**GUJARAT NRE NO.1 COLLIERY MAJOR  
EXPANSION  
PART 3A APPLICATION GROUNDWATER  
ANALYSIS**

NSW Department of Planning and Infrastructure

GEOTLCOV24840AA-AB  
19 June 2013

**RE: Gujarat NRE No.1 Colliery Major Expansion  
Part 3A Application Groundwater Analysis**

**Figure 9. Protrusion of the calculated potential drainage thickness above ground surface for Wonga East.**

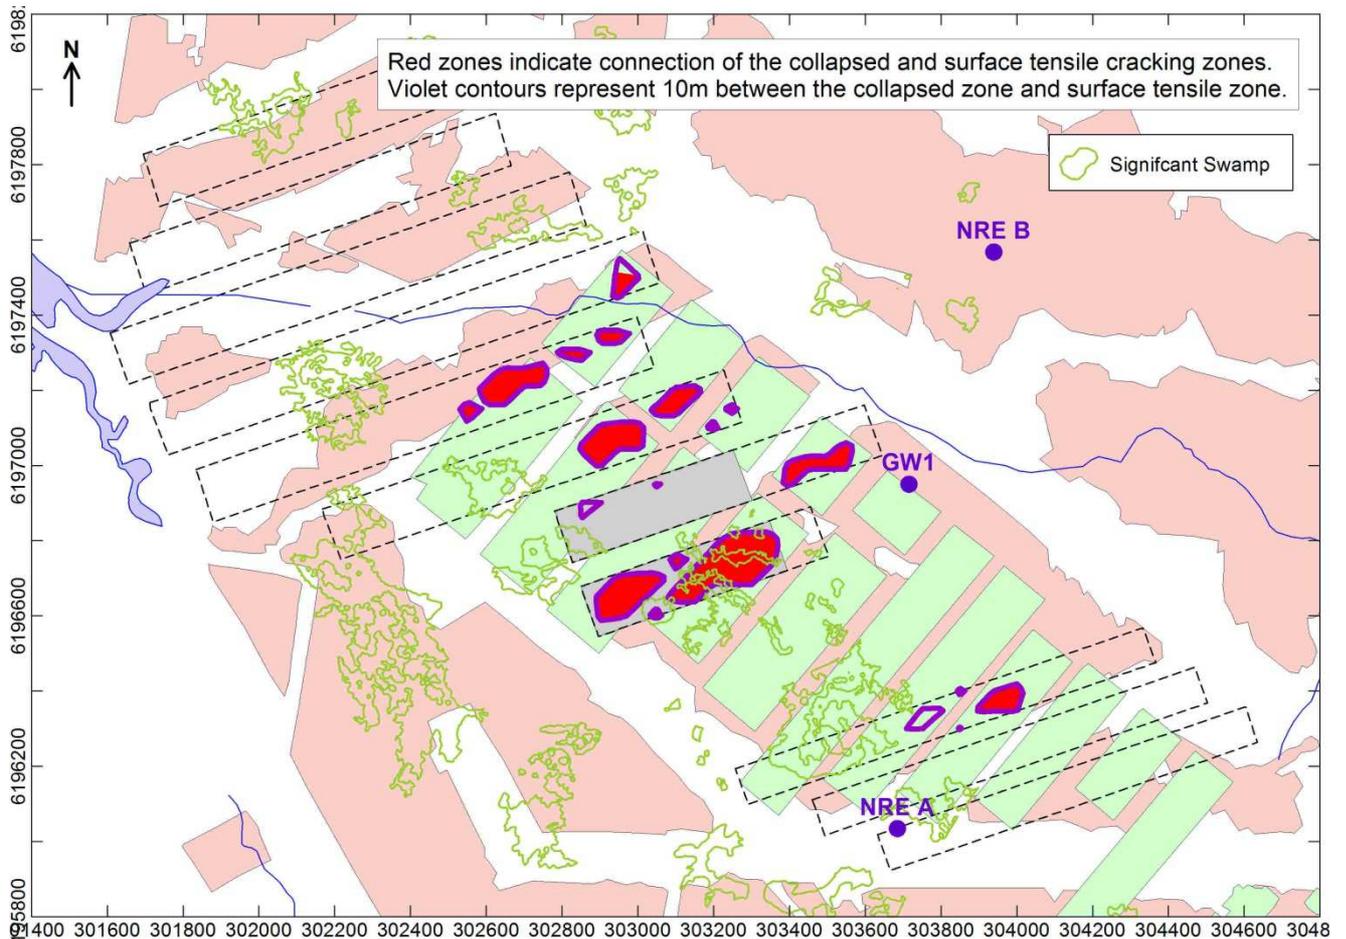
Figure 9 shows the protrusion of the interpreted potential drainage thickness above ground surface for Wonga East. Outlines of significant swamps are also shown. Complete drainage is calculated to occur over parts of LW3 to LW8.

A serious risk to Cataract Creek is present in the area where Cataract Creek, Balgownie LW11, a Bulli pillar extraction block, and Wongawilli panels LW7 and LW8 coincide (see Figures 9 and 1a). The interpretation indicates that the collapsed zone and surface tensile fracturing zones will connect in this area, and lead to creek drainage into the mined void. The calculated baseflow of Cataract Creek is 11.7 ML/day (see above), which is 6% of the average water volume generated by Lake Cataract between 2006 and 2012 (from the SCA water balance reports web page, sighted 14 May 2012: <http://www.sca.nsw.gov.au/publications/publications/sca-water-balance>).

**Figure 10. Protrusion of the calculated potential drainage thickness above ground surface for Wonga West**

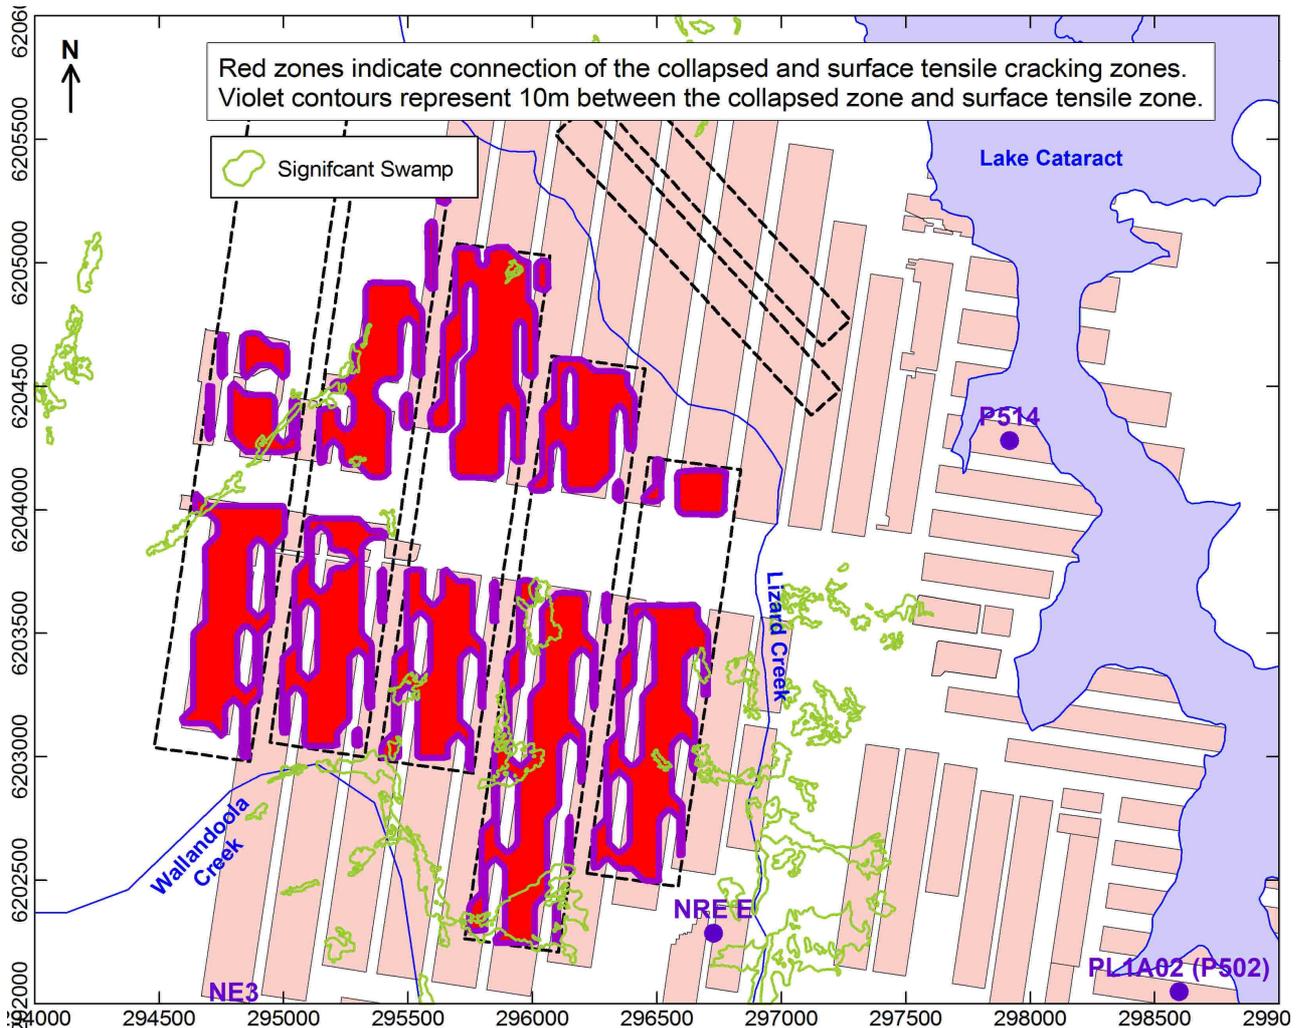
Figure 10 shows the protrusion of the interpreted potential drainage thickness above ground surface for Wonga West. Outlines of significant swamps are also shown. Complete drainage is calculated to occur over the proposed wide panels (LW1 to LW5) wherever they underlie Bulli seam workings. The zone of complete drainage comes to within about 100m of Lizard Creek at the northern end of LW2, and to within 100m of Wallandoola Creek at the southern ends of LW4 and LW5 (see Figures 10 and 1b). The interpretation indicates that the collapsed zone and surface tensile fracturing zone will connect in these areas, which may lead to creek drainage into the mined void.

Any swamp overlying a Wongawilli seam panel that underlies a Bulli seam panel will also overlie a zone of interpreted protrusion. Using Figure 5 of BR (2012), the largest four of these swamps are LCUS9, LCUS18, LCUS25, and WCUS4.

Figure 14a. Interpreted risk zone for Cataract Creek.

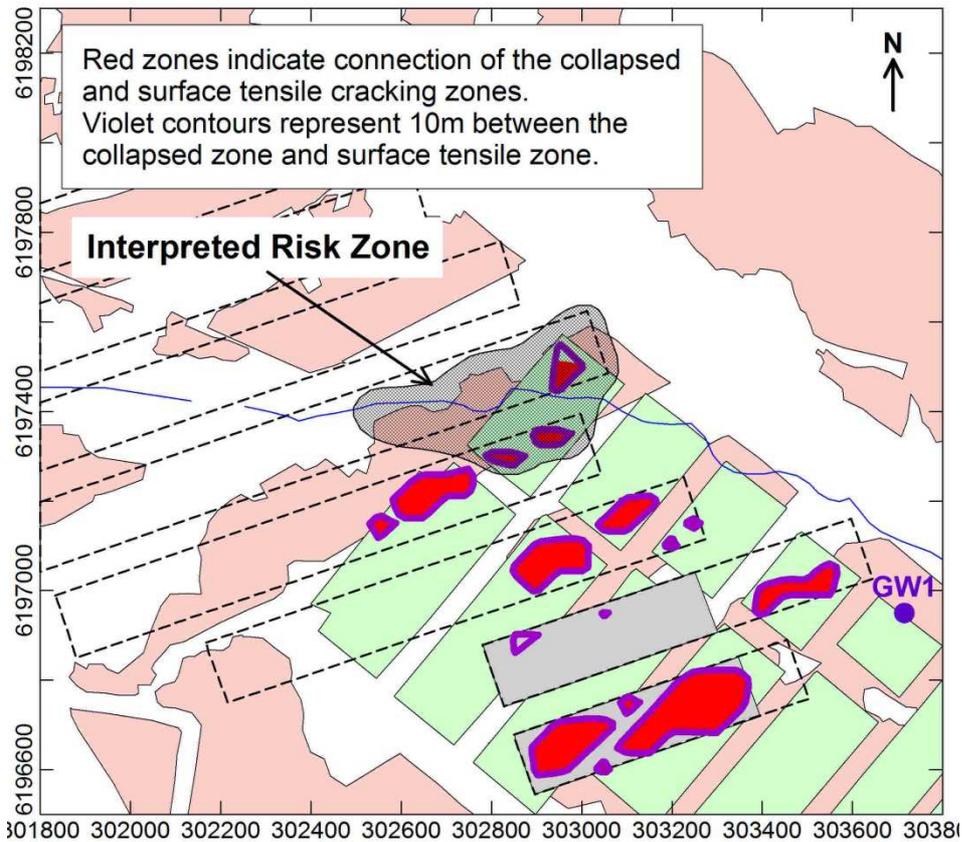
A serious risk of cracking from the mined seam up to creek base is assessed for Cataract Creek, in the area shown in Figure 14a. According to calculations by the proponent, and Upper Nepean water supply water balances viewed online, Cataract Creek supplies about 6% of the total water generated by Lake Cataract. The author knows of no post-mining hydraulic head measurements over multiple longwall-mined coal seams. Unfortunately, reduction of risk using historical observations will not be possible until a world-wide database of direct hydraulic head measurements down the profile at (at least) about 10 locations over multiple mined seams world-wide is available. The risk to Cataract Creek is therefore considered immitigable.

Figure 14b. Interpreted risk zones for Wallandoola and Lizard Creeks.

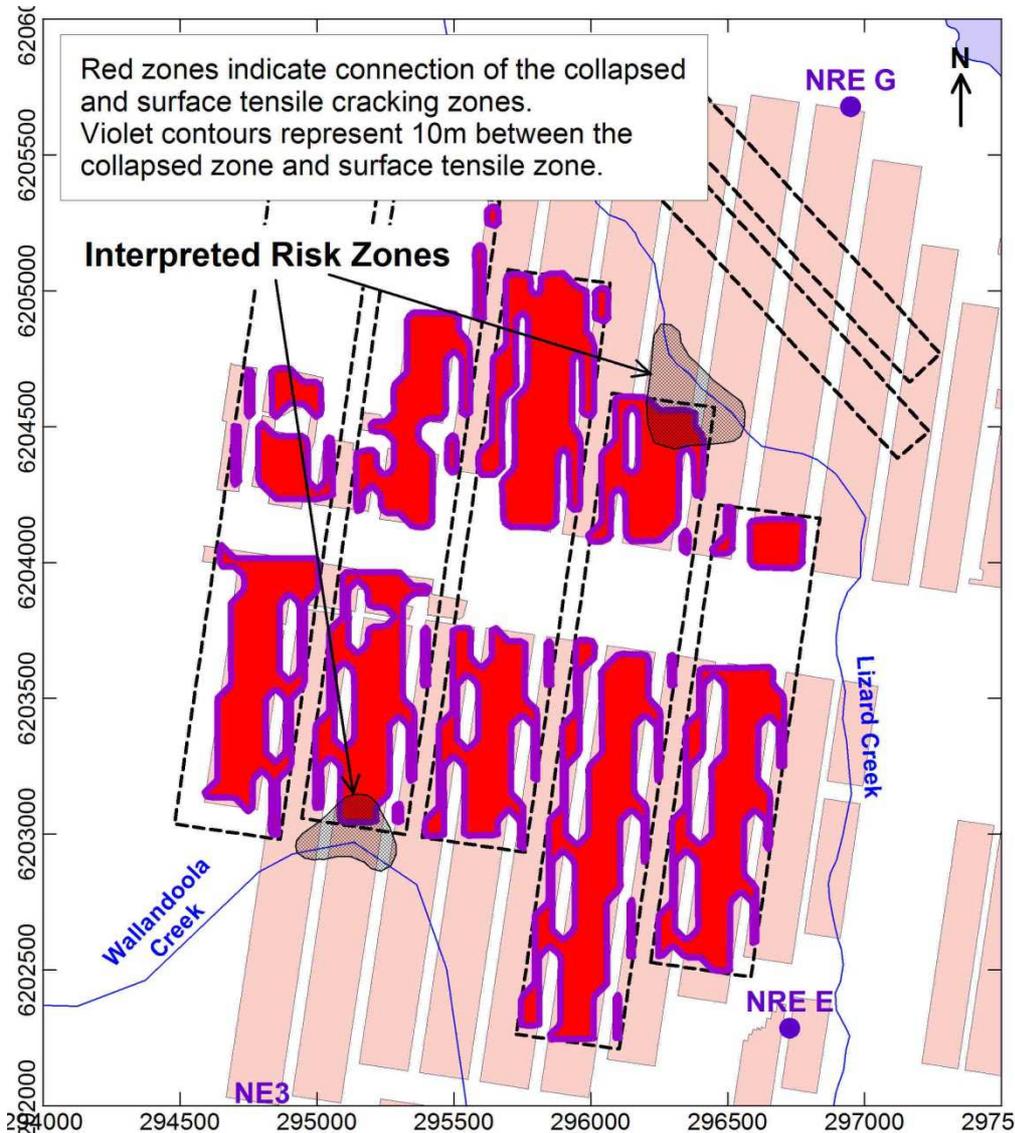
A serious risk of cracking from the mined seam up to the creek base is assessed for Wallandoola and Lizard Creeks, in the areas shown in Figure 14b. These creeks do not flow into Lake Cataract, however according to calculations by the proponent, and Upper Nepean water supply water balances viewed online, Lizard and Wallandoola Creeks have a combined average flow equal to about 25% of the total water generated by Lake Cataract.

- Most of swamp CCUS6 at Wonga East (using Figure 4 of BR, 2012) (see Figure 14a).
- Any swamp overlying a Wongawilli seam panel that underlies a Bulli seam panel at Wonga West. The largest four of these swamps at Wonga West are LCUS9, LCUS18, LCUS25, and WCUS4 (using Figure 5 of BR, 2012) (see Figure 14b).

**Figure 1. Comparison of previous and current mine plans for Wonga East. Current mine plan sourced from Gujarat (2013) and overlaid with georeferenced information from Coffey (2013). Comparison of Panel Layouts for Wonga East.**

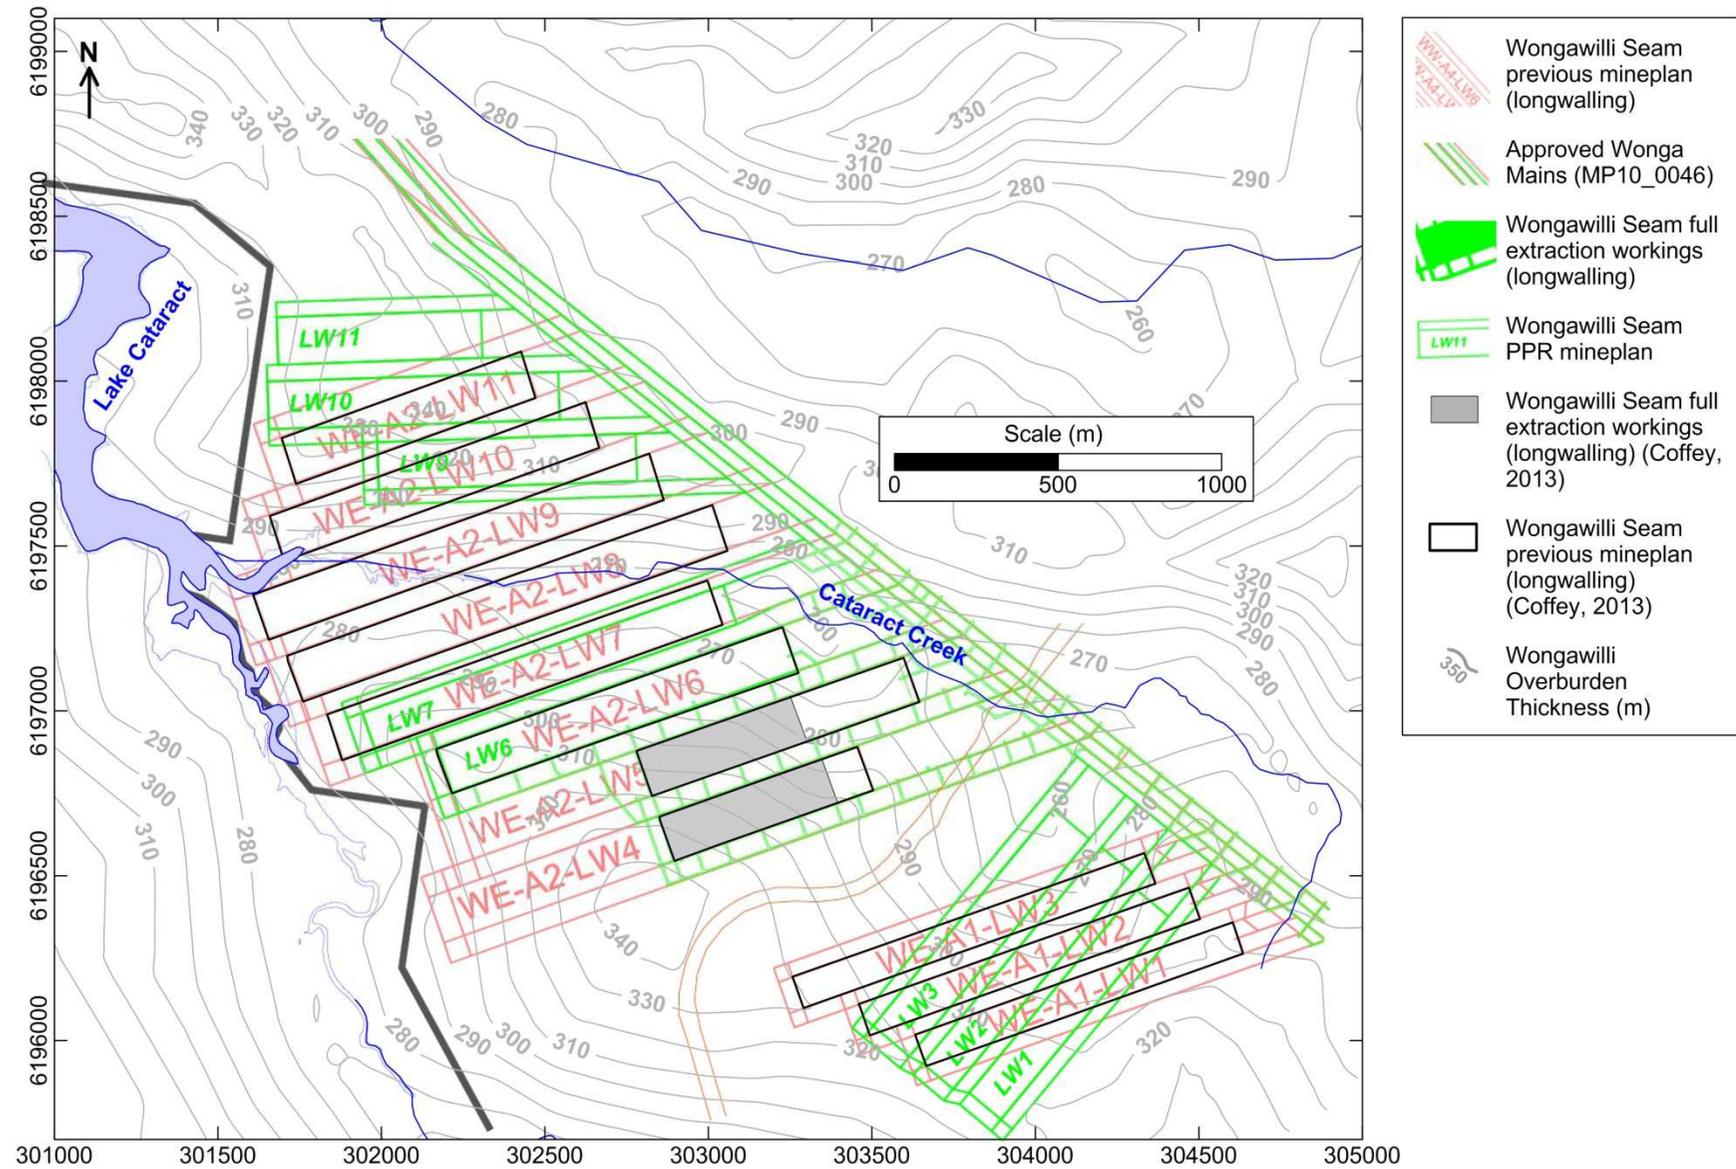
The new mine plan is presented in Figure 4 of the PPR however no scale is shown and it is not georeferenced. This mine plan was positioned with respect to the MGA by overlaying the EA and PPR mine plans of Figure 4 of the PPR onto a georeferenced drawing of the EA mine plan, and scaling it until a visual match was obtained between the two versions of the EA mine plan. The result is shown in Figure 1. This process allowed positioning of Cataract Creek (not shown in Figure 4 of the PPR) with respect to LW7 of the PPR mine plan. However, the positioning error from this process is unknown.

Based on the new mine plane, the PPR states that there is an interpreted risk of significant secondary impact to swamps BCUS4 and CCUS4.

The new layout of LW7 (Figure 1) is still considered to pose a risk to the capacity of the channel of Cataract Creek to transmit surface water. A significant element of the risk is demonstrated by the indication provided by subsidence monitoring of Balgownie and Wongawilli Seam panels in Wonga East as discussed in the PPR. Incremental Balgownie panel subsidence ranged between 0.9m and 1.2m where overlying Bulli goaf (room and pillar panels with pillar extraction) was present, approaching 80% of the mined height (implying a mined height of about 1.5m for the Balgownie panels). In unusual areas (latent subsidence, goaf edge), the incremental subsidence reached 1.4m, approaching 100% of the mined height. Figure 2a (after Figure 49 of the PPR) shows these results.

**Figure 4. New proposed position of Wongawilli LW7 as per the PPR.**

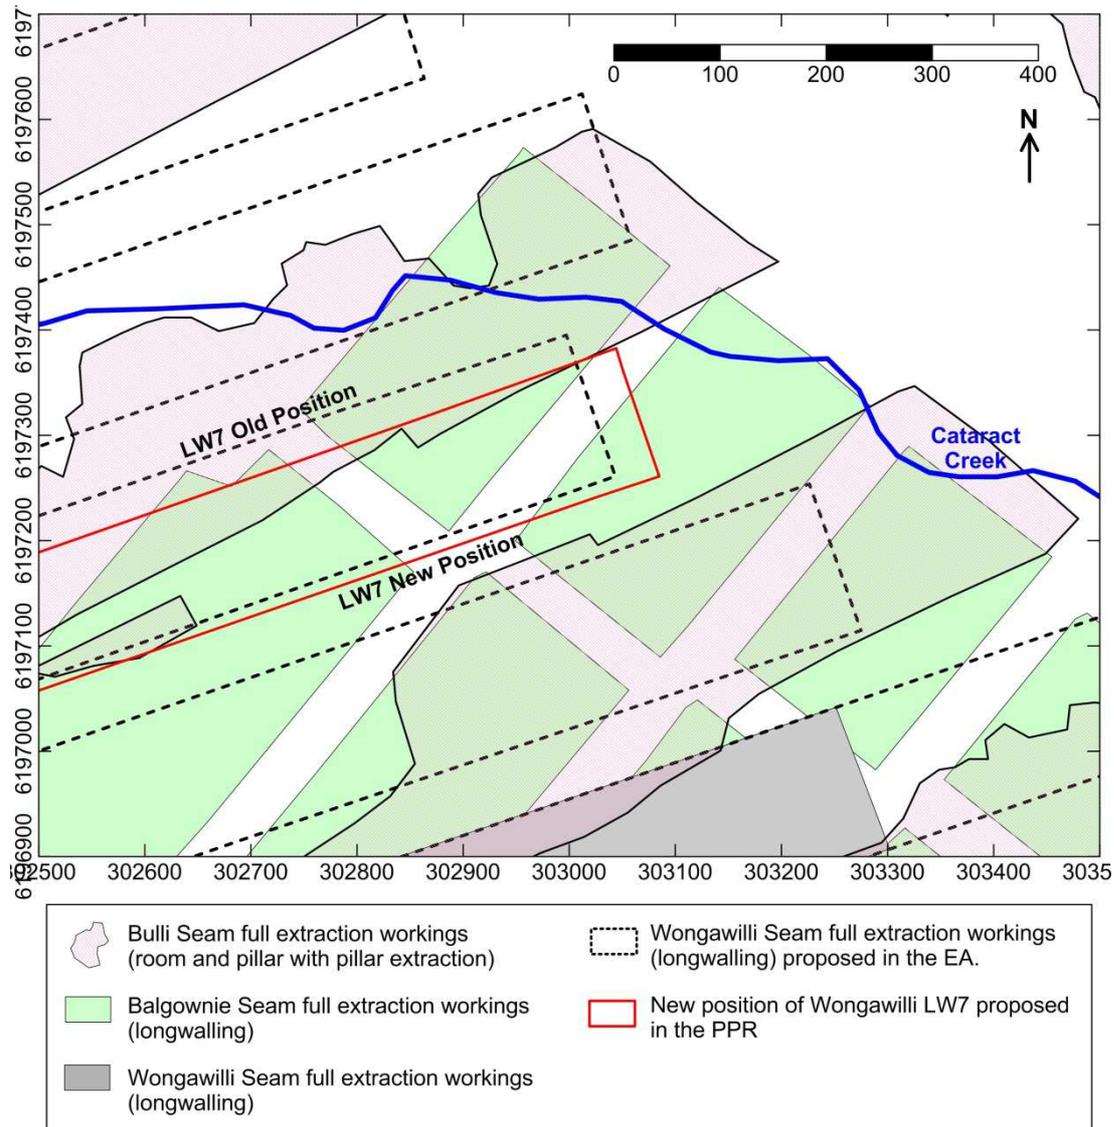
The new layout of LW7 is shown in detail in Figure 4. Subject to the accuracy of the positioning of the panels (the positioning of the new mine plan is approximate (see above) and the channel centreline was digitised from information in Geoterra 2012a, 2012b, and ERM, 2013, see also Coffey, 2013), it appears that the last 40m of the new LW7 position ceases to be overlain by any part of the adjacent Bulli room and pillar panel. The localised northern corner of LW7 is now positioned under a small, about 50m wide, devoid of existing full extraction workings.

The minimum separation distance between the northern corner of LW7 and the Cataract Creek channel centreline is approximately 45m (see Figure 4). Despite the absence of existing full extraction workings over a small strip of about 50m width, there may still be a risk to the capacity of the channel of Cataract Creek to transmit surface water. There may also still be a risk of direct hydraulic connection between the creek channel and goaf, through the collapsed zone, where the channel comes to close to the panel edge. The significance of these risks cannot be quantified, but warrants consideration.
